Date: December 9, 2004
Order No.: P-B-49.10/09
Supersedes:
Group: 49

**SUBJECT: Model 171.456, up to chassis F042765
Routing of O2 Sensor Harness**

Figure 1

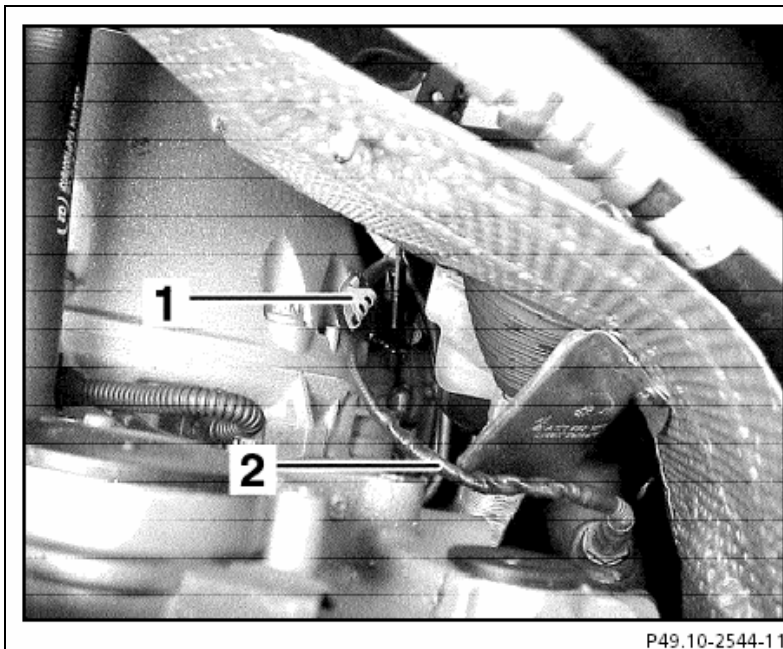
It is NOT required to have the O2 sensor harness (see picture item 2) on the left and right side secured in the retaining clip (Figure 1, 1). As of chassis # F042765 the retaining clips (Figure 1, 1) on the left and right side will no longer be installed.
